# **SUPPLEMENT to the CARRIZO ENERGY SOLAR FARM APPLICATION for CERTIFICATION**

**APPLICATION FOR CERTIFICATION (07-AFC-8)  
Carrizo Energy Solar Farm  
Carrizo Energy, LLC**

**Submitted by:  
Carrizo Energy, LLC**

**July 2008**

AUSRA	JOB NUMBER	REV
CARRIZO ENERGY SOLAR FARM	113226	A
SOLAR FIELD LAYOUT	DRAWING NUMBER	M1-1

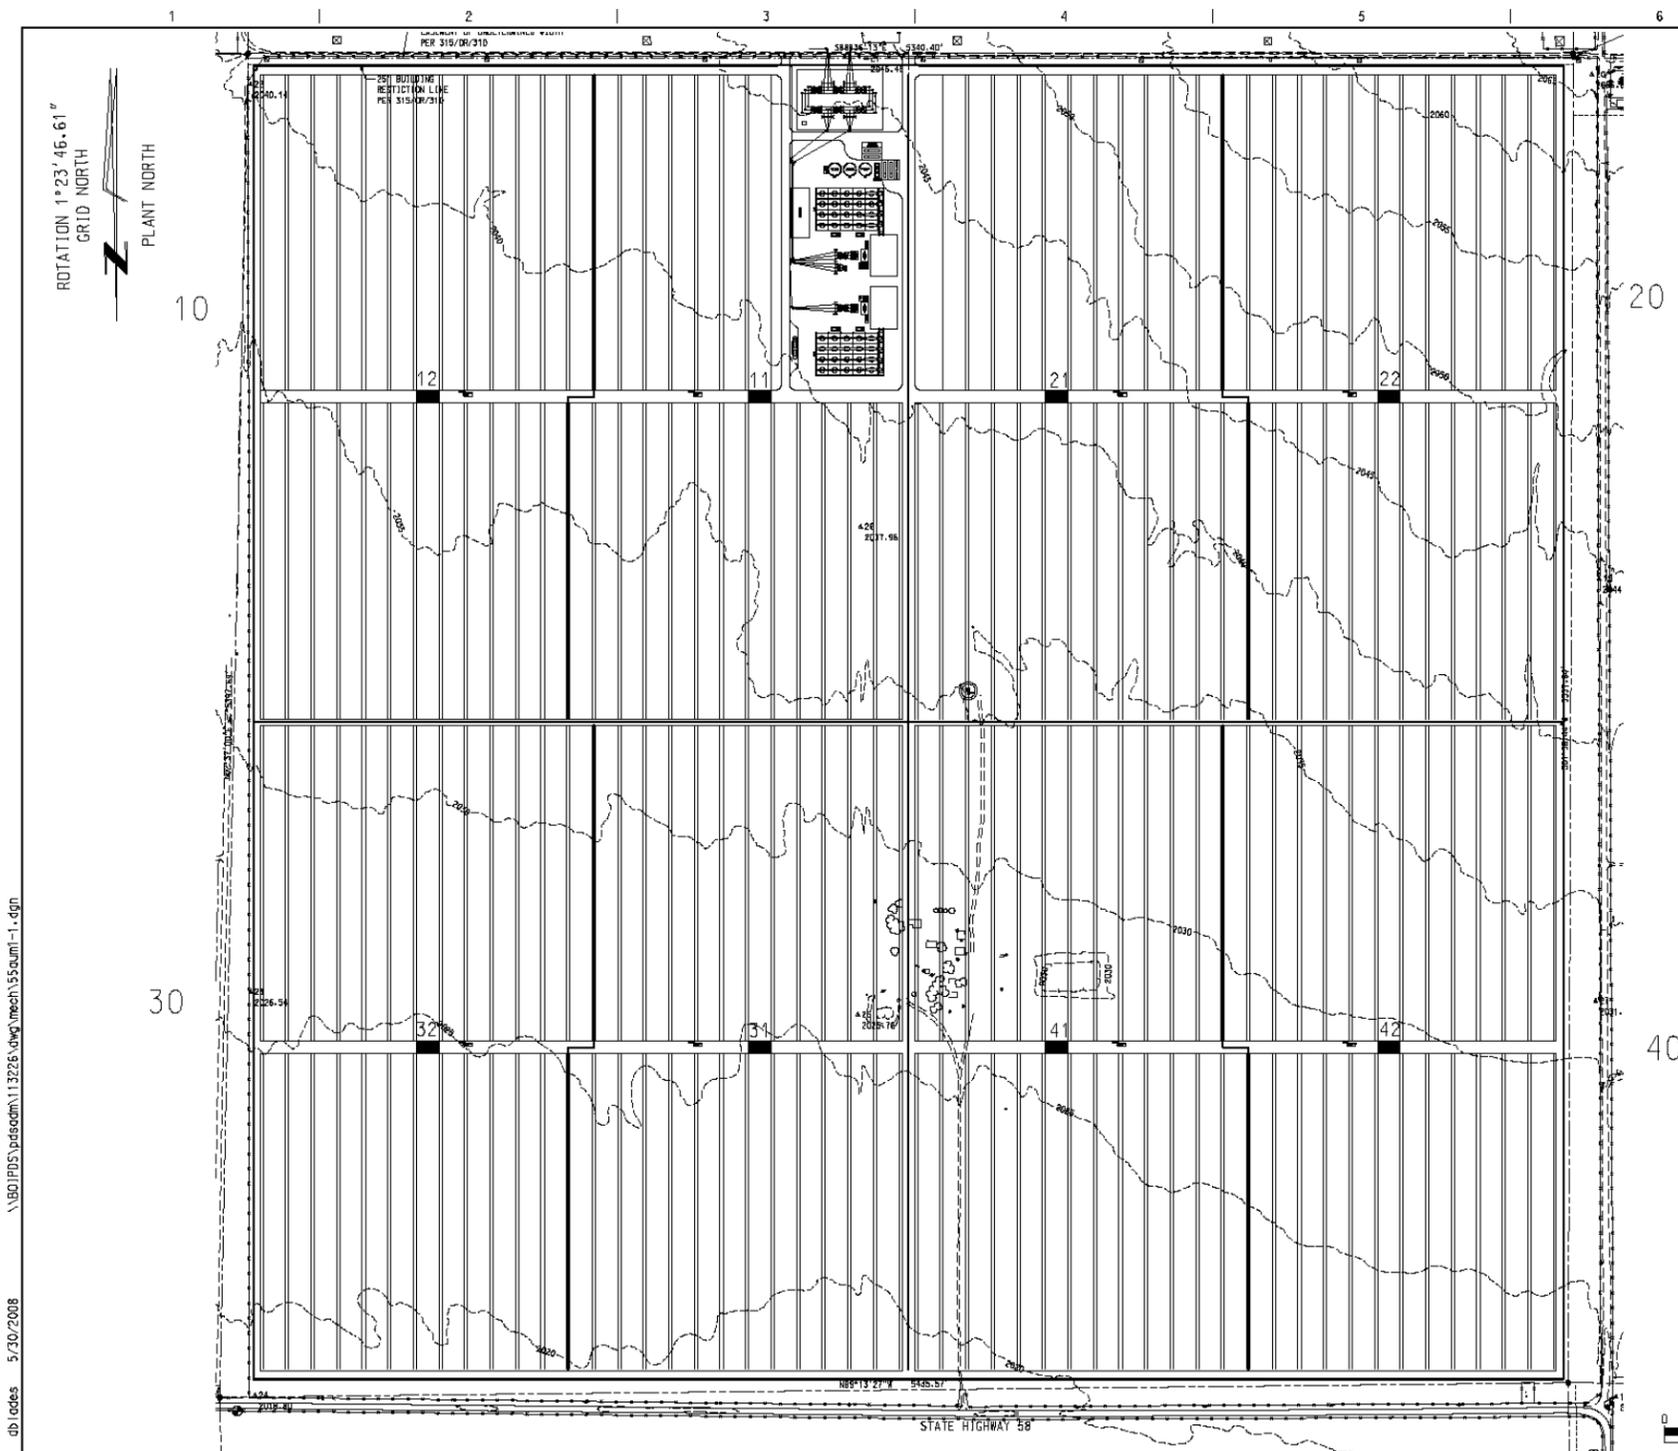
The power block would be reoriented as a result of the new configuration. The power block would be located on the eastern side of the northwestern quadrant of Section 28, and resituated in a north/south direction, as shown in Figure 1.2-1. This configuration will reduce potential visual and noise impacts at key sensitive receptors.

located in the solar field, and then to the two steam turbine generators in the power block (see Figure 1.2-1).

JOB NUMBER	REV
113226	A
DRAWING NUMBER	
M1-4

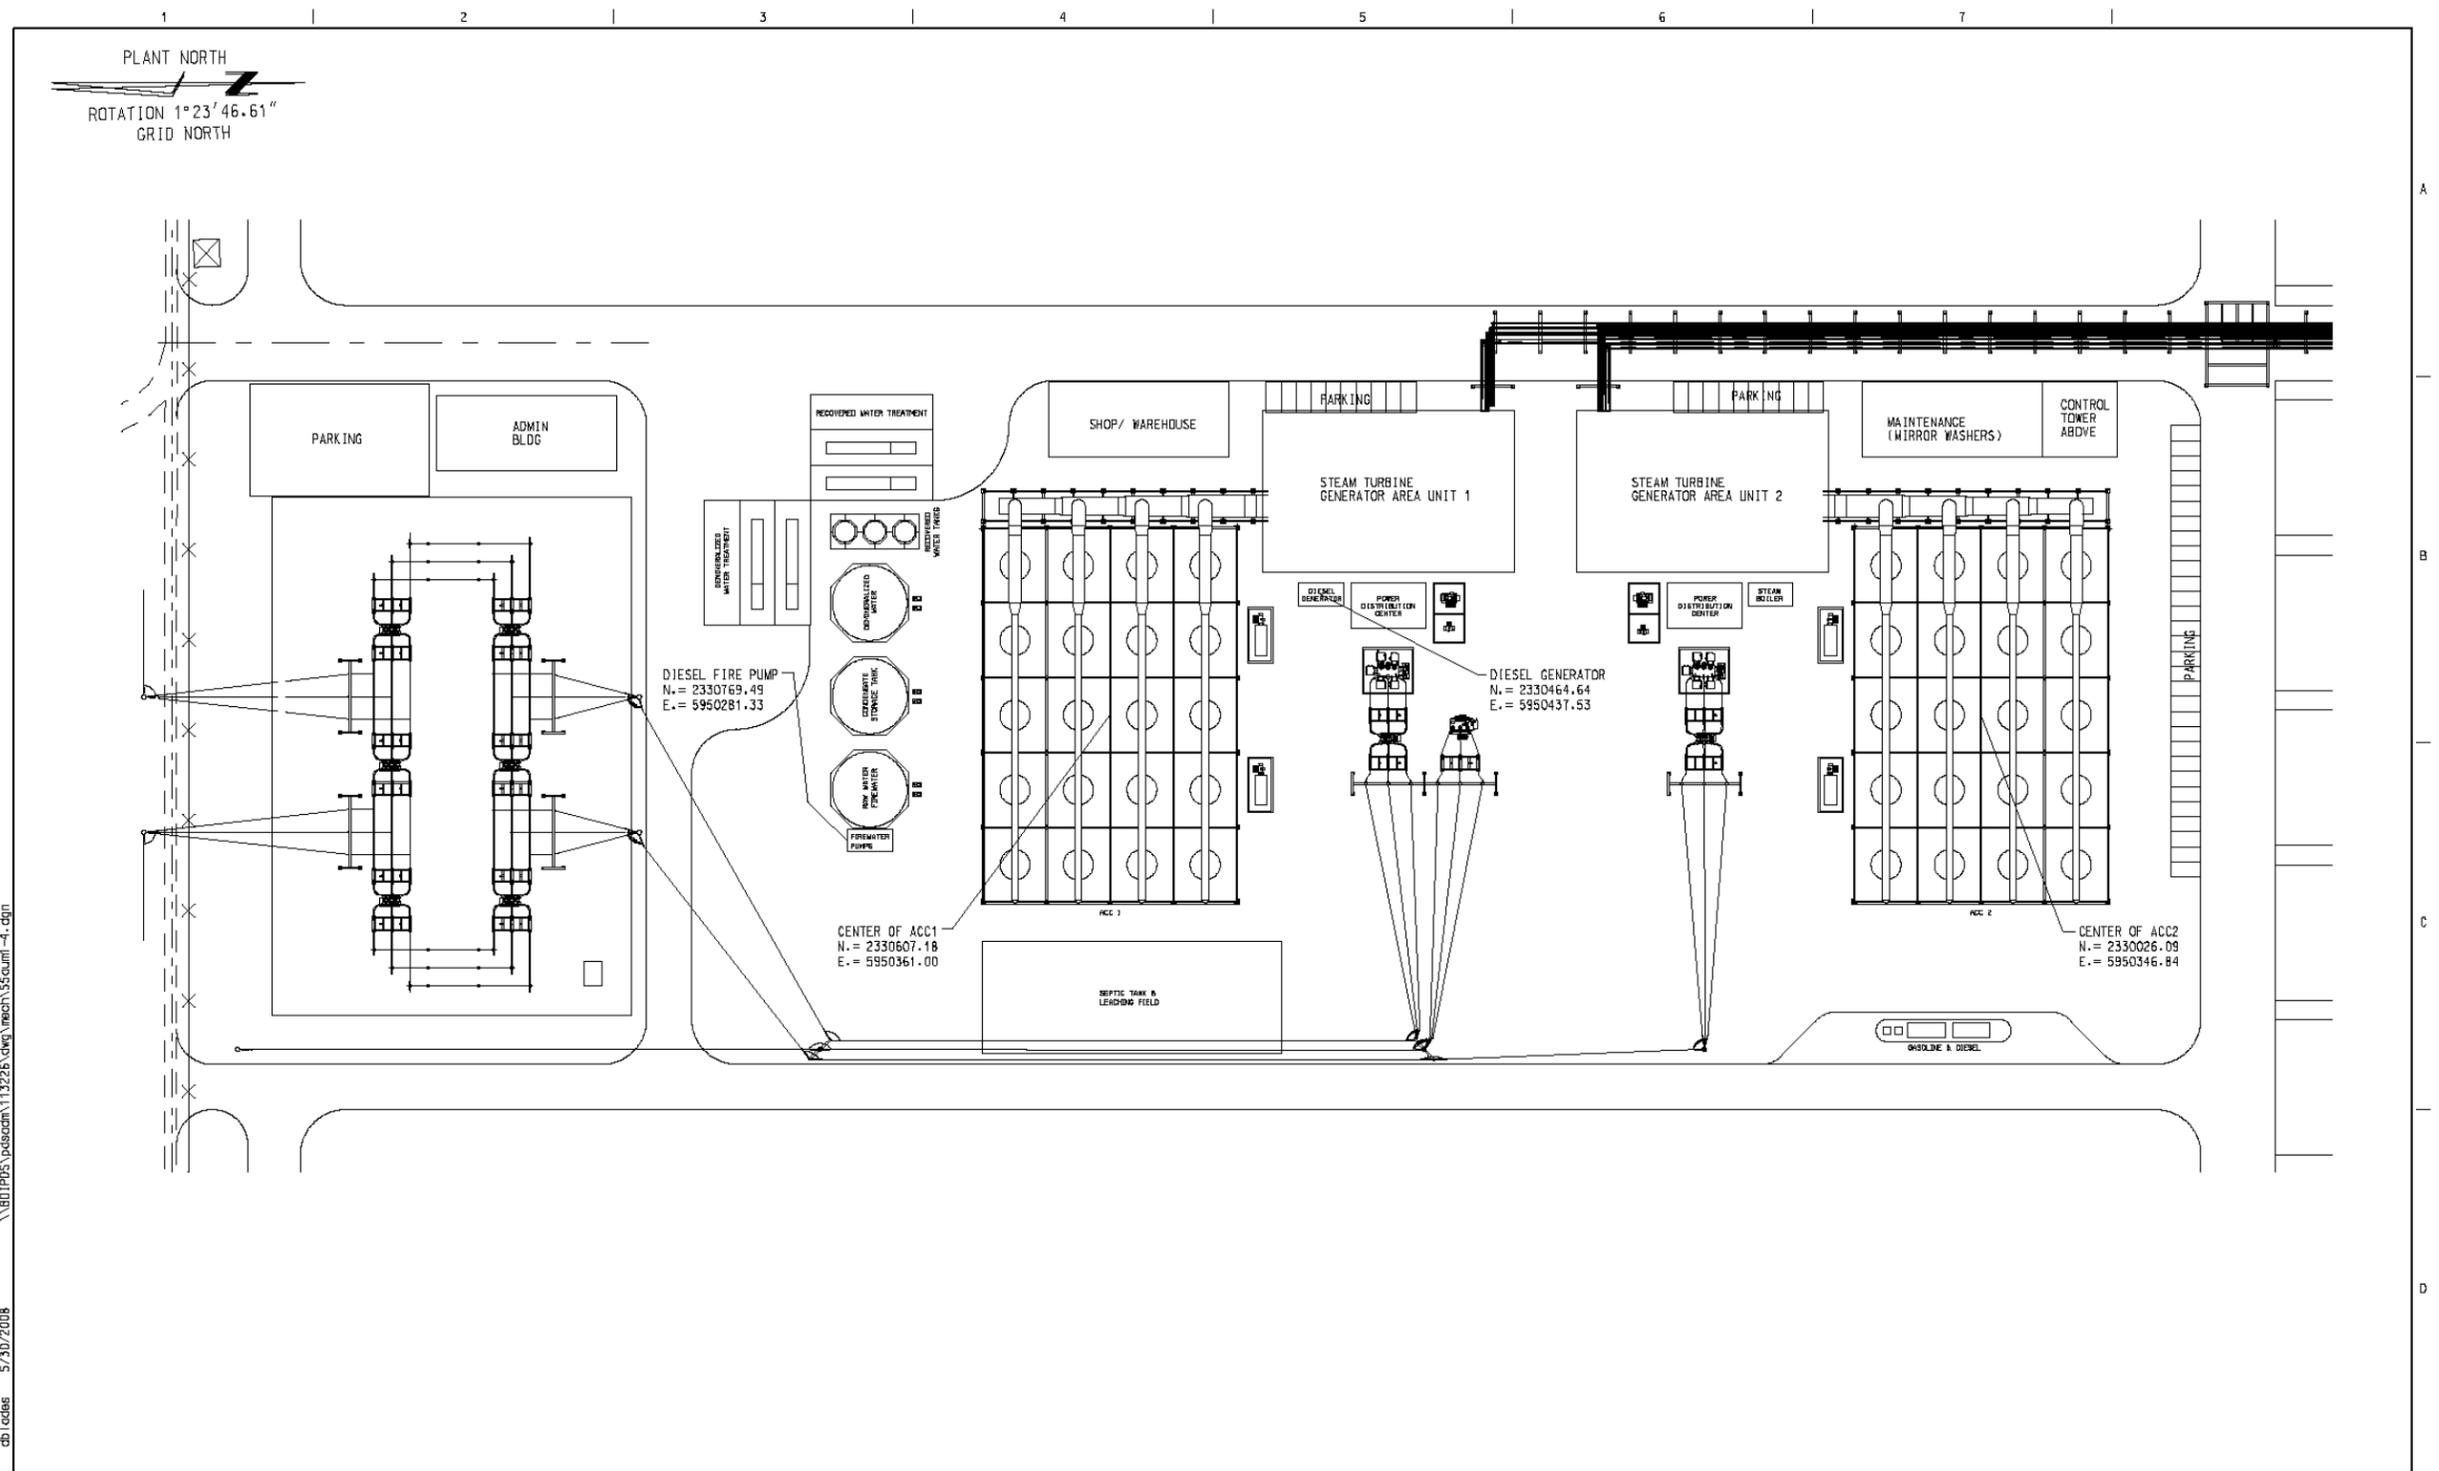
The Project AFC describes two twenty-five cell ACCs located within the power block; however, per this supplemental filing, the ACCs will contain only twenty cells each (see Figure 1.2-4). This will reduce noise generation.

In the event there is a loss of power from the Pacific Gas & Electric (PG&E) system, an approximate 1 MW emergency diesel generator will power the 4160V bus in order to supply power for control and monitoring instrumentation as well as other essential services, including but not limited to communications, control air, steam turbine lube oil and tuning gear, emergency lighting, transient 480V motor operated valve loads, and other miscellaneous loads. The generator and its associated fuel tank will be located within a weather enclosure in the power block, as shown on Figure 1.2-4.

**PRELIMINARY GRADING & DRAINAGE PLAN  
CARRIZO ENERGY SOLAR FARM (CESF)**

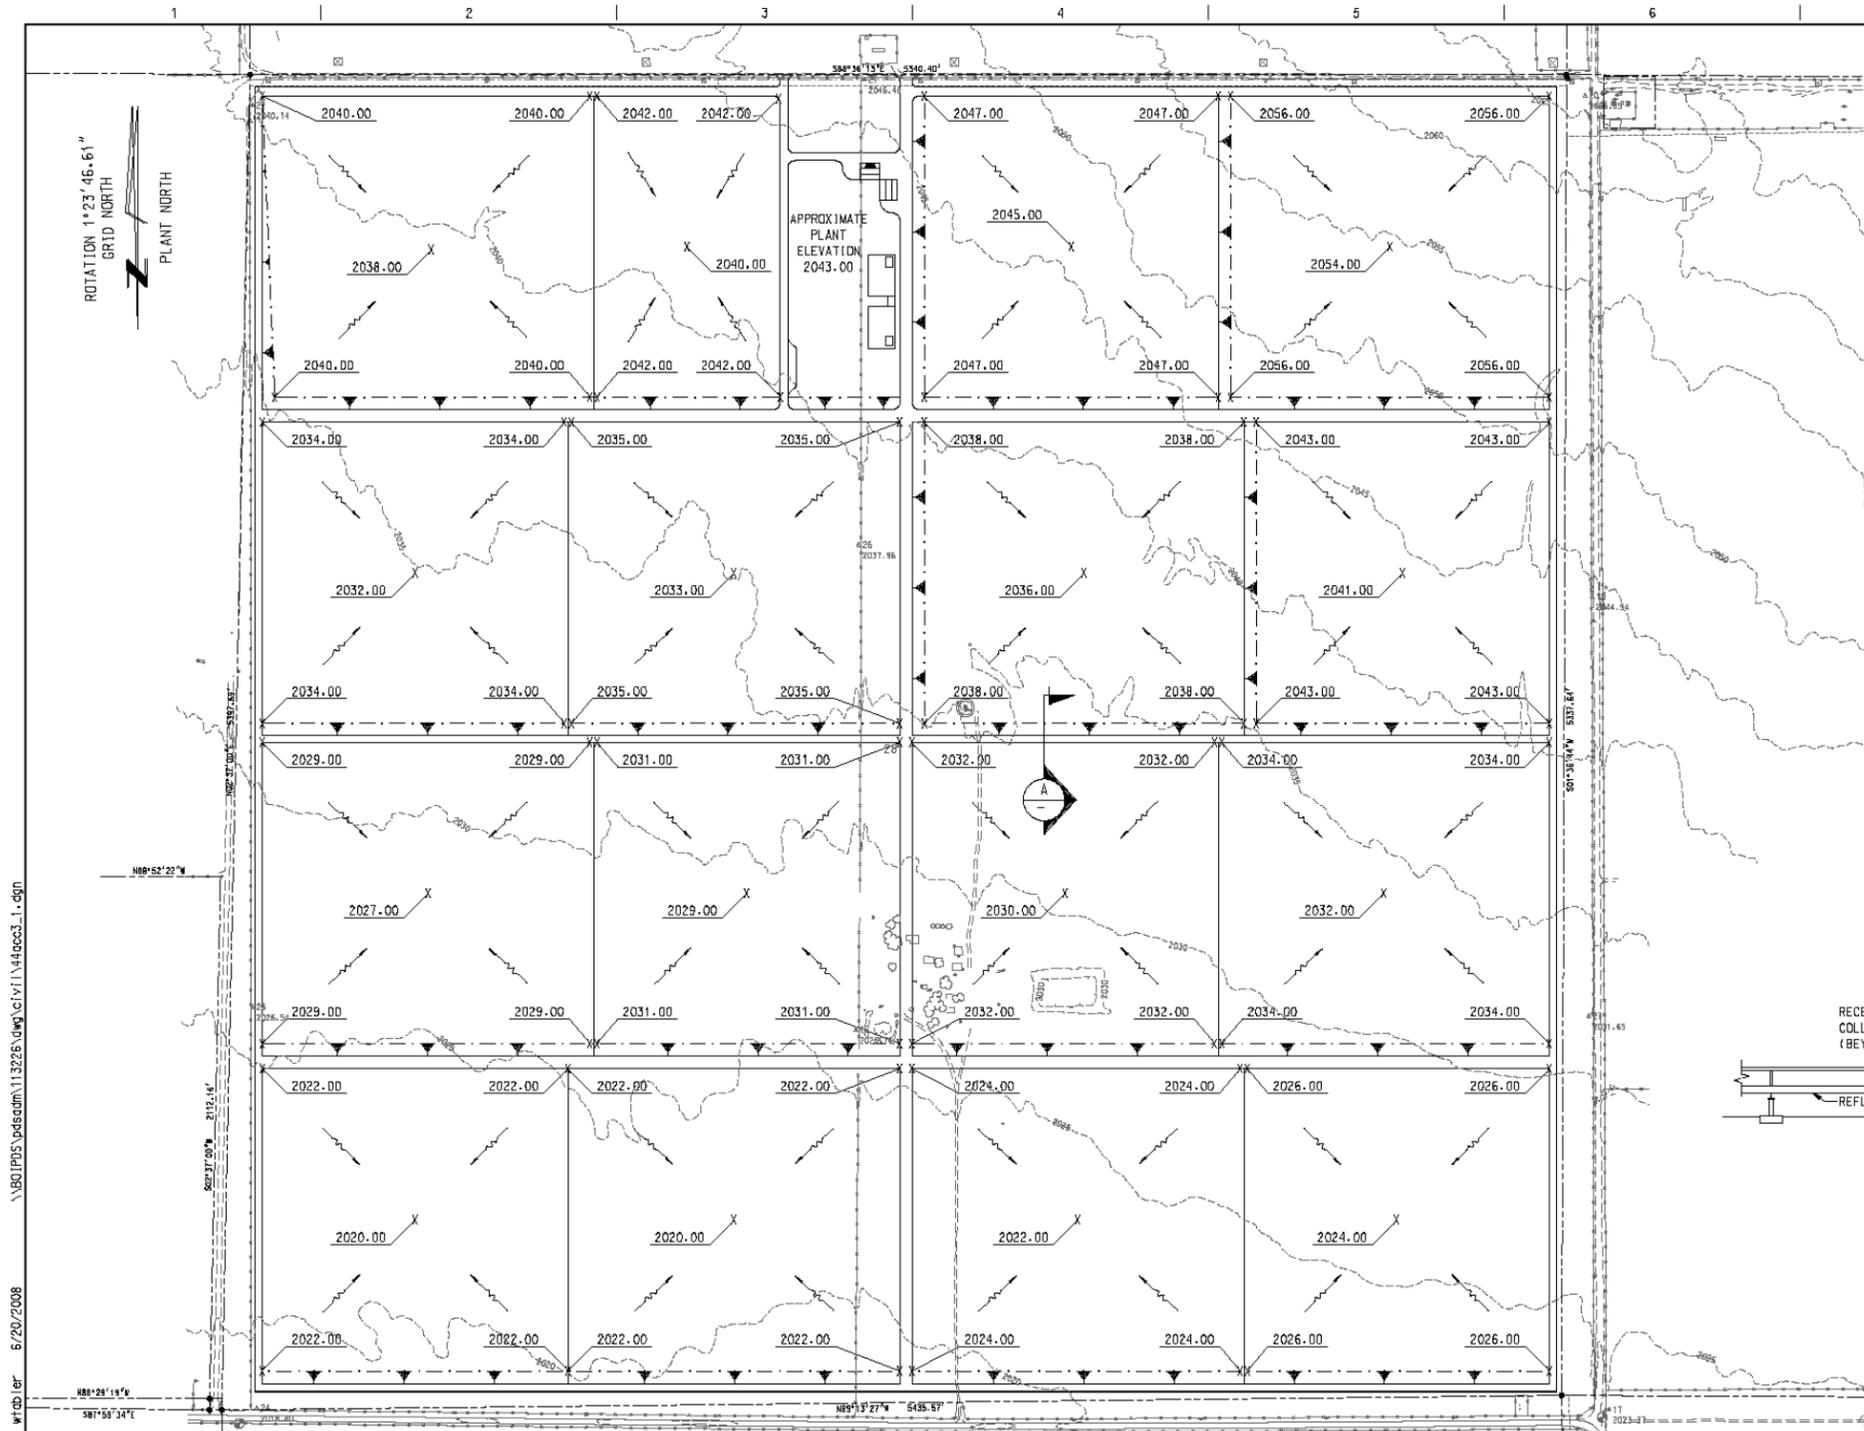
The site grading and drainage plan reflects the changes to the Project configuration (see Figure 1.2-6 and Appendix A, Drainage Erosion and Sediment Control Plan (DESCP)).

The only change to water resources due to the reconfiguration of the solar lines involves the flow of water. The water will now flow to 16 low spots designed to contain and infiltrate surface runoff; however, the previous configuration included only 6 low spots. The DESCP, included as Appendix A, shows the calculations that indicate the revised grading plan provides adequate mitigation for onsite stormwater.
